Subject: Response to Third Adequacy Review
Application Amendment #5
Mine Land Reclamation Permit M-1977-300, Schwartzwalder Mine, Golden, Colorado

M-1977-300 APPLICATION AMENDMENT #5, COMMENT AND RESPONSE SUMMARY TABLE

APPLICATION AMENDMENT 5, MINE PERMIT M-1977-300 SCHWARTZWALDER MINE, GOLDEN, COLORADO

FIGURE F-1
RECLAMATION PLAN MAP

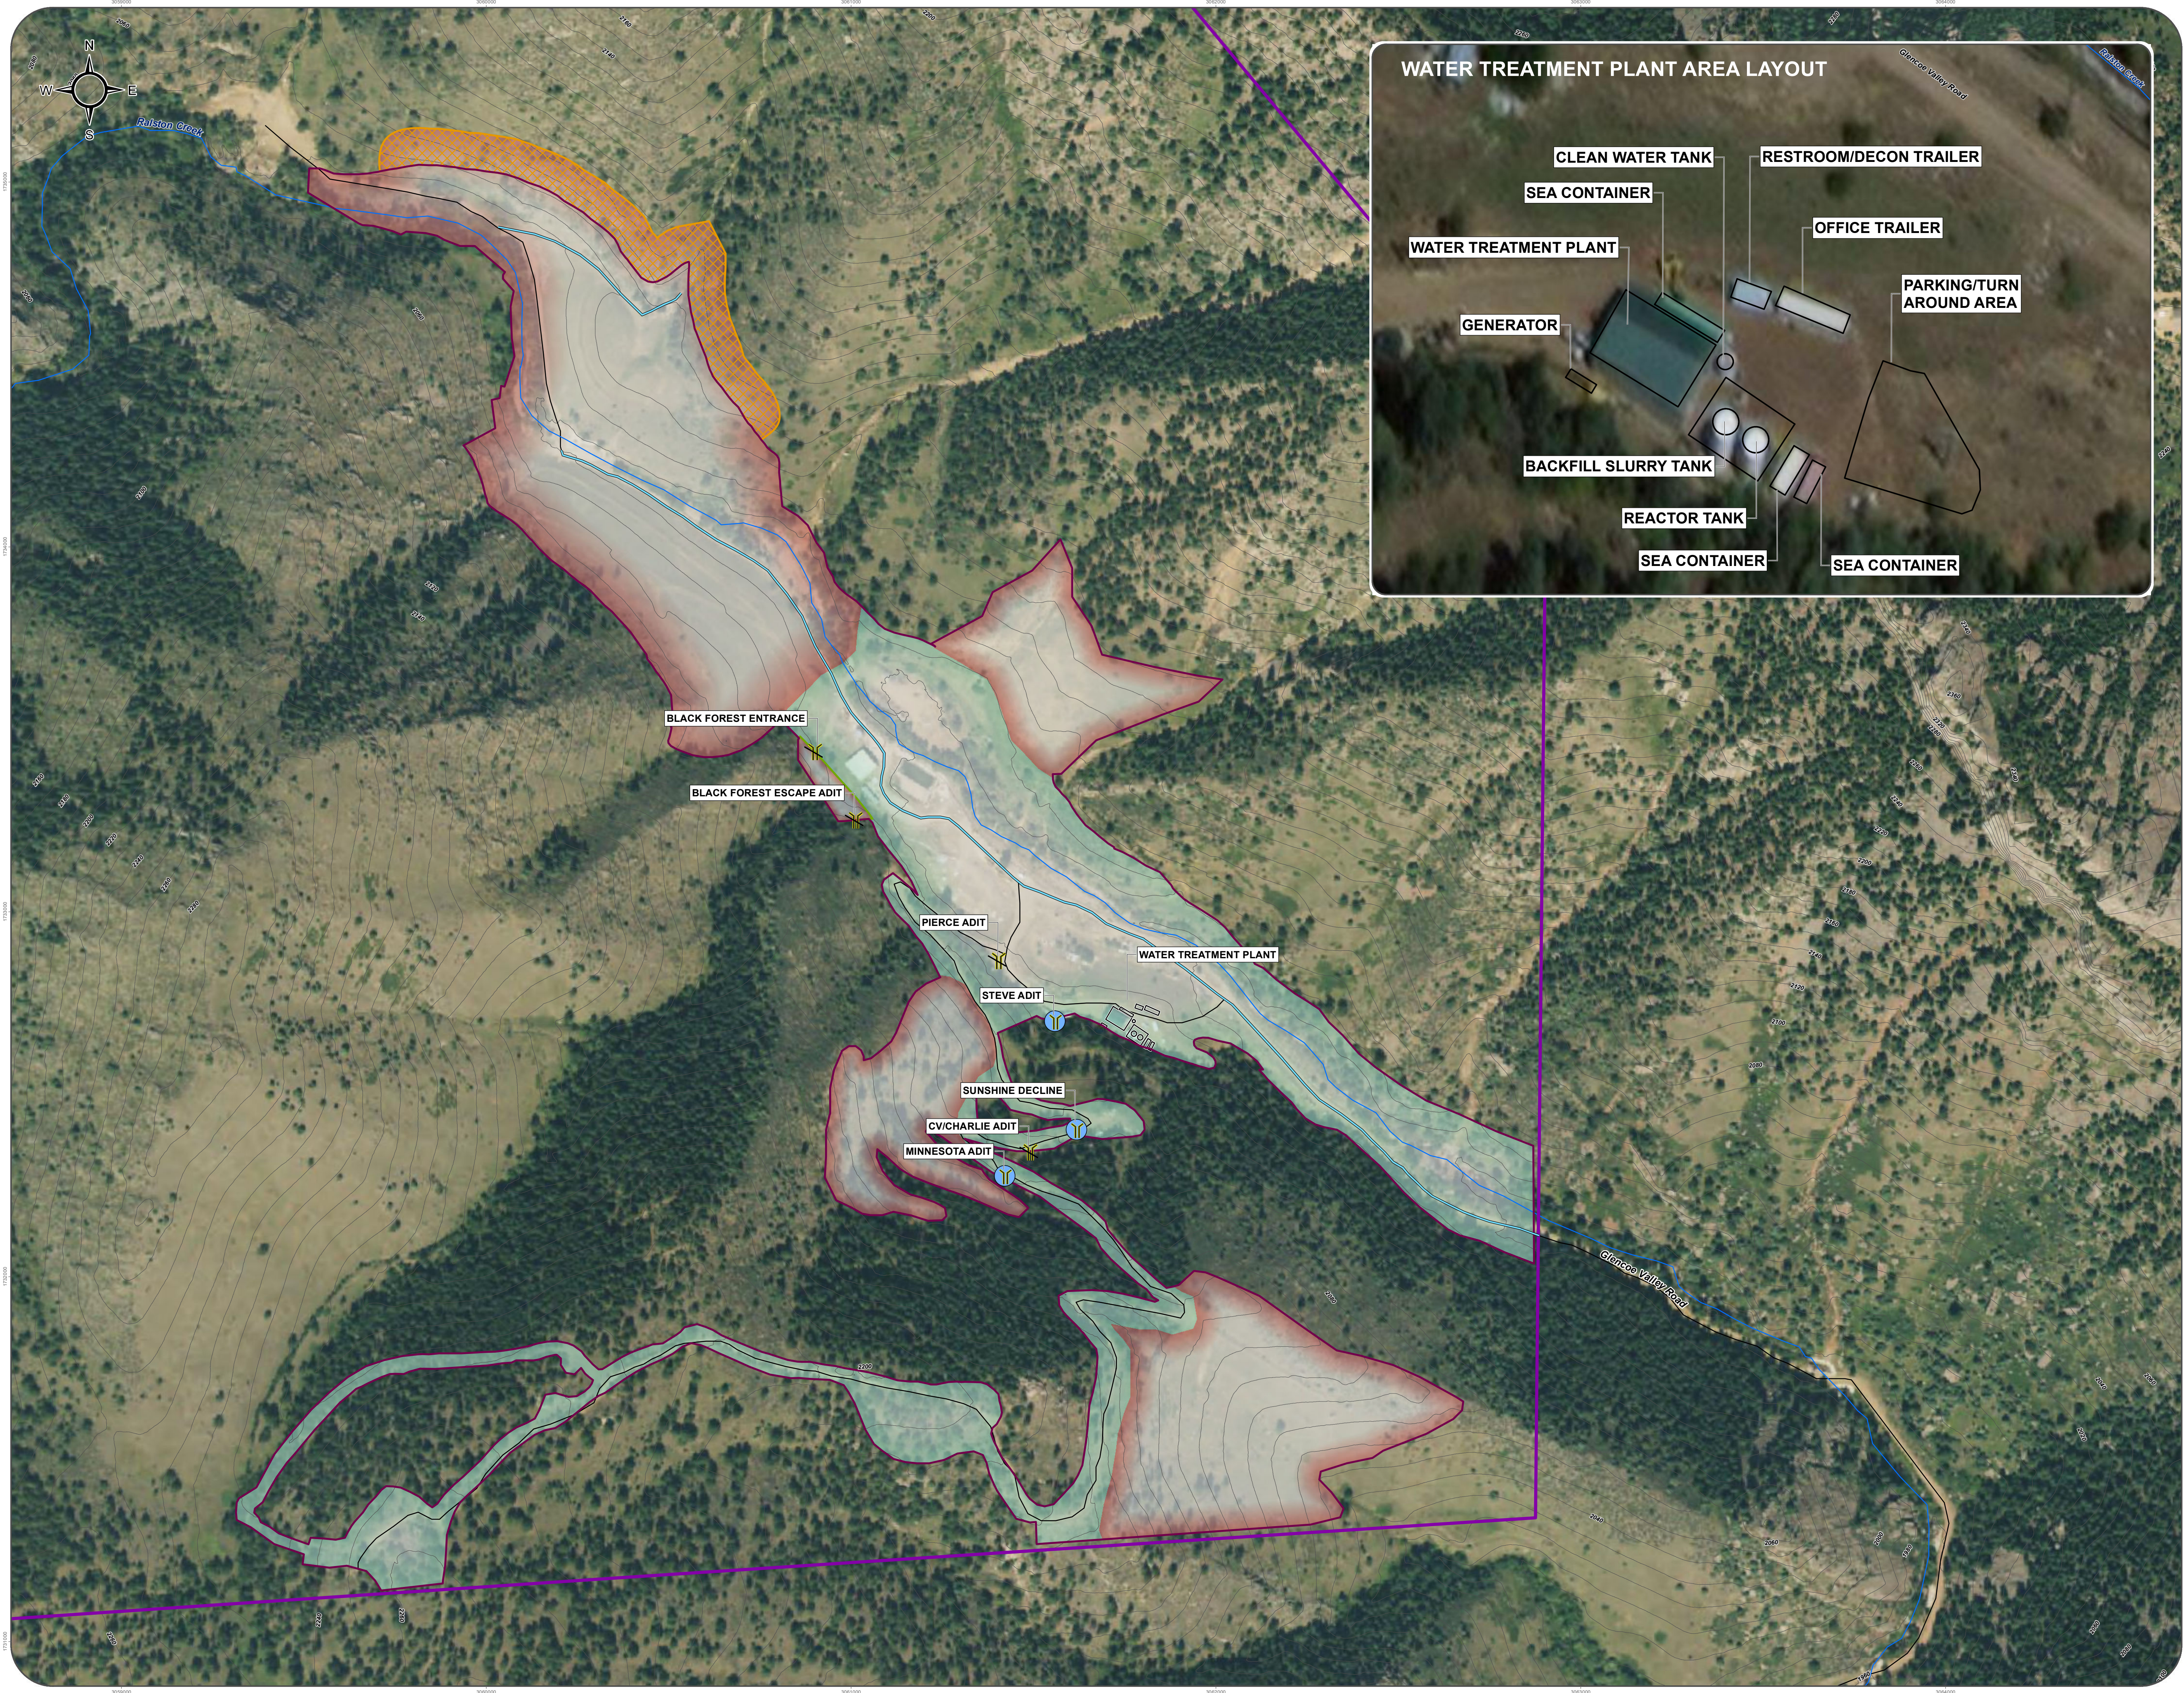
2	<u>Exhibit F – Reclamation Plan Map (Rule 6.4.6):</u> In your response, reference is made to a Figure F-2 submitted to address adequacy item #8 in the Division's December 3, 2020 Adequacy Review No. 2 letter. This figure could not be found in the materials submitted. Please submit Figure F-2 showing a closer view of the Black Forest Mine area which portrays the expected physical appearance of the backfilled mine openings.	The previous response inadvertently referenced "Figure F-2". The original comment and revised response are provided below: <i><u>Comment:</u> Exhibit F – Reclamation Plan Map (Rule 6.4.6): Please provide a separate Exhibit F map (or an inset on Figure F-1) showing a closer view of the Black Forest Mine area which portrays the expected physical appearance of the backfilled mine openings. This map should depict the approximate dimensions of the backfill area, show the approximate final slope gradients, and indicate areas to be retopsoiled and revegetated for reclamation.</i> <i><u>Response:</u> Figure F-1 has been revised to illustrate the final slope gradients. The expected appearance of the mine openings, included the areas to be retopsoiled and revegetated are shown on the closure schematic illustrated on Figure E-1.</i>
